# Arrival Fashion Limited (Bhaluka)

20 December 2023

## 2. Observations

### Observation-1: Inconsistency in design report and FEA model (Garments Shed).

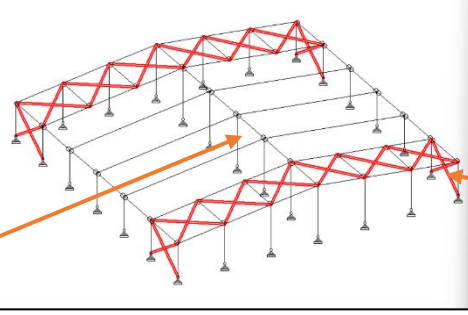
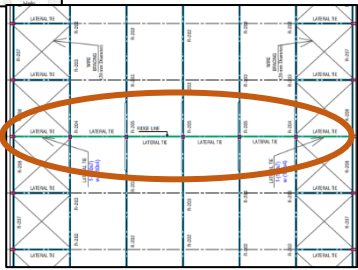
ASD design code has been used with ASD load combination.

In FEA model, rod section has been assigned as vertical bracing instead of I-section.

AISC LRFD design code is used in design report.

These compression members are missing in FEA model.

**Description:** The Garments shed has been designed in accordance with AISC LRFD as per design report. However, ASD design code with ASD load combinations was observed in FEA model. Also, inconsistency was found in horizontal compression member and vertical bracing assignment. The building engineer is required to revise the design report considering the effect of compression member and proper design code.

| Observation                                                   | Action Plan                                                                                                                                                                                  | Timeline        |
|---------------------------------------------------------------|----------------------------------------------------------------------------------------------------------------------------------------------------------------------------------------------|-----------------|
| Inconsistency in design report and FEA model (Garments Shed). | The building engineer is required to revise the design report considering the effect of compression member and proper design code.                                                           | within 6 weeks  |

### Observation-2: Mismatch in as built drawings (Garments Shed).

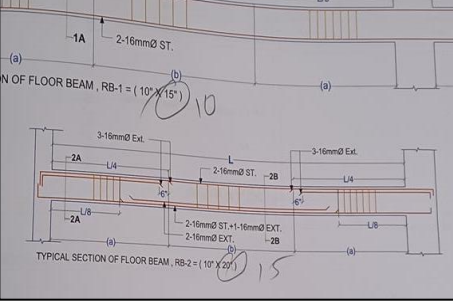
Eave height was found 6.01m instead of 4.87m.

Mezzanine floor beam depth was found 250 mm instead of 375 mm.

Extended portion of the rafter has not shown in drawing.

**Description:** During inspection, mismatches were found between onsite condition and as-built drawing of garment shed. Extended part of the rafter was not shown in the drawing. Also, mismatches were observed in mezzanine floor beam size and eave height of the shed. The building engineer is required to survey the full structure and produce accurate as-built drawings.

| Observation                                                   | Action Plan                                                                                                                                                                                  | Timeline        |
|---------------------------------------------------------------|----------------------------------------------------------------------------------------------------------------------------------------------------------------------------------------------|-----------------|
| Mismatch in as built drawings (Garments Shed).                | The building engineer is required to survey the full structure and produce accurate as-built drawings.                                                                                       | within 6 weeks  |

**Observation-4: Non-structural element found not anchored. (Garments Shed).**

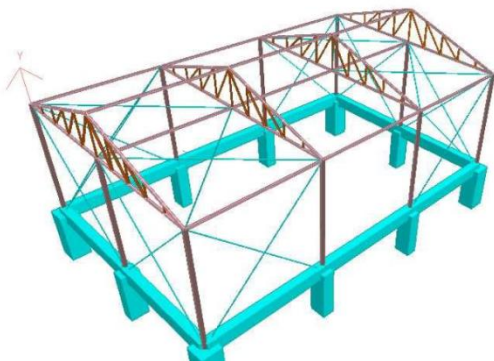
Storage Rack – not anchored

Plastic Water Tank on mezzanine roof  
not braced

**Description:** During inspection non-structural elements were found unbraced and without anchoring. Factory engineers are required to anchor all non-structural elements.

| Observation                                                   | Action Plan                                                                                                                                                                                  | Timeline        |
|---------------------------------------------------------------|----------------------------------------------------------------------------------------------------------------------------------------------------------------------------------------------|-----------------|
| Non-structural element found not anchored. (Garments Shed).   | Factory engineer is required to anchor/brace all non-structural elements.                                                                                                                    | within 6 weeks  |

**Observation-5: Lack of Lateral Stability (Dining Shed-01)**

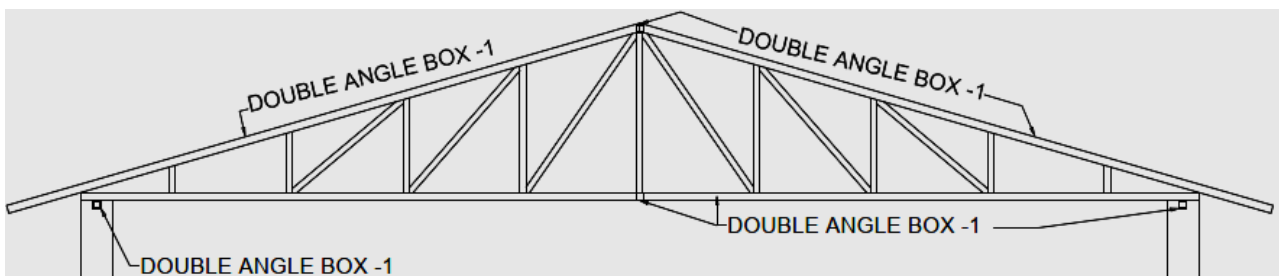
Wall Bracing in FEA model

Bracing Missing in side wall

Wall Bracing not shown in marked position in Retrofitting drawing

Bracing Missing in end frame

**Description:** Wall bracings were not shown in retrofitting drawings and not found in as built condition which are necessary for lateral stability of the frame. Building engineer is required to check the lateral stability of the shed considering the as built condition and submit to the RSC for review.

| Observation                                                   | Action Plan                                                                                                                                                                                  | Timeline        |
|---------------------------------------------------------------|----------------------------------------------------------------------------------------------------------------------------------------------------------------------------------------------|-----------------|
| Lack of Lateral Stability (Dining Shed-01)                    | Building engineer is required to check the lateral stability of the shed considering the as built condition and submit to the RSC for review.                                                | within 6 weeks  |

**Observation-6:** Incomplete retrofitting works (Dining Shed-01)

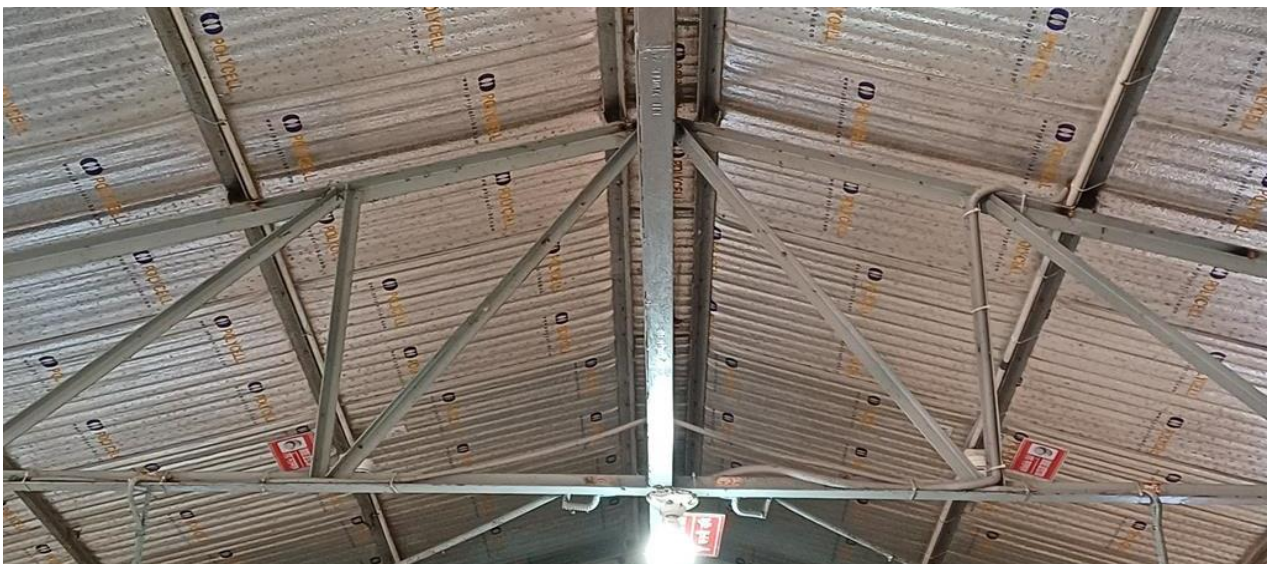
Truss Section

Top & Bottom Chord found L 50x50x5 instead of steel tube (50x50x5)

**Description:** During inspection, top & bottom chords were found L 50x50x5 instead of steel tube (50x50x5). Building engineer is required to complete the remediation works as per retrofitting drawings.

| Observation                                                   | Action Plan                                                                                                                                                                                  | Timeline        |
|---------------------------------------------------------------|----------------------------------------------------------------------------------------------------------------------------------------------------------------------------------------------|-----------------|
| Incomplete retrofitting works (Dining Shed-01)                | Building engineer is required to complete the remediation works as per retrofitting drawings.                                                                                                | within 6 months |

**Observation-9: Discrepancies in as built drawings (Dining Shed-02).**

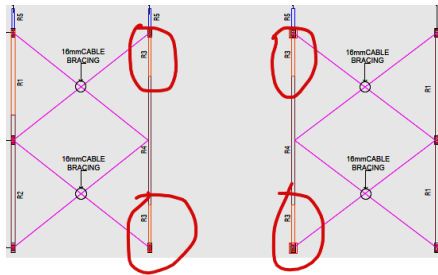
**Description:** During inspection, the web depth of Rafter-3 was found 440 mm instead of 540 mm. Building engineer is required to survey the whole structure and update as-built drawing as per site condition.

| Observation                                                   | Action Plan                                                                                                                                                                                  | Timeline        |
|---------------------------------------------------------------|----------------------------------------------------------------------------------------------------------------------------------------------------------------------------------------------|-----------------|
| Discrepancies in as built drawings. (Dining Shed-02)          | The building engineer is required to survey the full structure and produce accurate as-built drawings.                                                                                       | within 6 weeks  |

**Observation-10: Design report needs to be updated (Garments Building).**

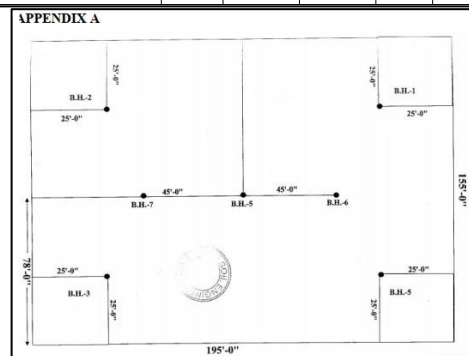
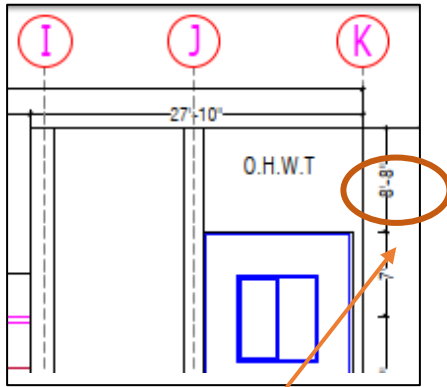
'R' value used in design report.

No calculation of 'R' or check for 'DUAL system' has given in design report.

Pile capacity has been calculated from the average capacity of 5 bore hole data.

7 Bore Hole as per Bore hole layout.

**Description:** Garments building has been designed as per BNBC 2020 and Response modification factor 'R' value was taken for DUAL system (IMRF and Special RC Shear wall). However, no calculation of 'R' or check for dual system has been provided in design report. Also, load bearing capacity of pile has been calculated from the average value of 5 Bore Hole data where 7 Bore holes were investigated. The building engineer is required to revise the design documents considering the requirements for framing system as per BNBC 2020 and appropriate calculation for pile load bearing capacity.

| Observation                                                   | Action Plan                                                                                                                                                                                  | Timeline        |
|---------------------------------------------------------------|----------------------------------------------------------------------------------------------------------------------------------------------------------------------------------------------|-----------------|
| Design report needs to be updated (Garments Building).        | The building engineer is required to revise the design documents considering the requirements for framing system as per BNBC 2020 and appropriate calculation for pile load bearing capacity | within 6 months |

**Observation-11:** Load plans need to be revised (Garments Building).

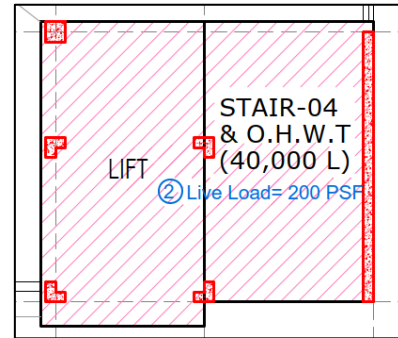
Possible overloading from  
higher capacity O.H.W.T.

Equivalent Water  
height of 200 psf live  
load is 0.975 m which  
is lower than existing  
capacity (2.34m) of  
O.H.W.T.

200 psf was considered on bottom  
slab of O.H.W.T. as per load plan.

**Description:** Garments building has been designed with a live load of 200psf for overhead water tank. However, the size of the water tanks has 475psf (2.34m of water height) which can cause overloading on the structures. The building engineer is required to update the load plan for actual capacity of water tank and incorporate it in design report.

| Observation                                                   | Action Plan                                                                                                                                                                                  | Timeline        |
|---------------------------------------------------------------|----------------------------------------------------------------------------------------------------------------------------------------------------------------------------------------------|-----------------|
| Load plans need to be revised (Garments Building).            | The building engineer is required to update the load plan for actual capacity of water tank and incorporate it in design report.                                                             | within 6 weeks  |

**Observation-14:** Corrosion on steel member (Boiler Shed).

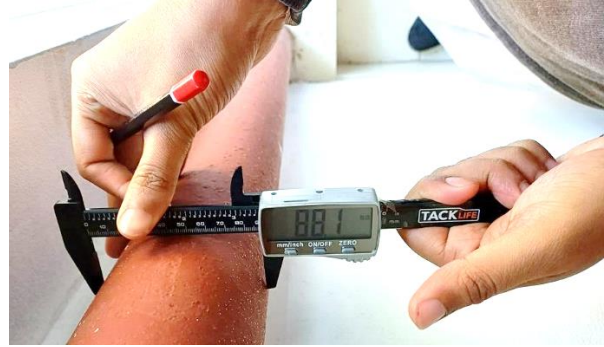
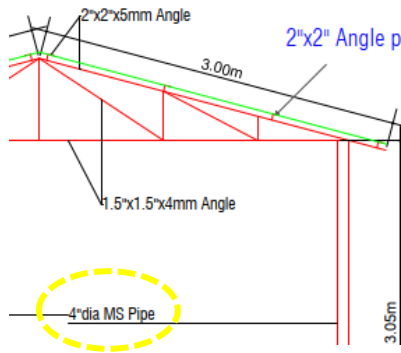
Rafter

Column

**Description:** During inspection, corrosion was observed on several steel columns and rafters. Building engineer is required to repair the corrosion and apply anti-corrosive coating on steel members.

| Corrosion on steel member (Boiler Shed).                       | Building engineer is required to repair the corrosion and apply anti-corrosive coating on steel members.                                                           | within 6 weeks  |
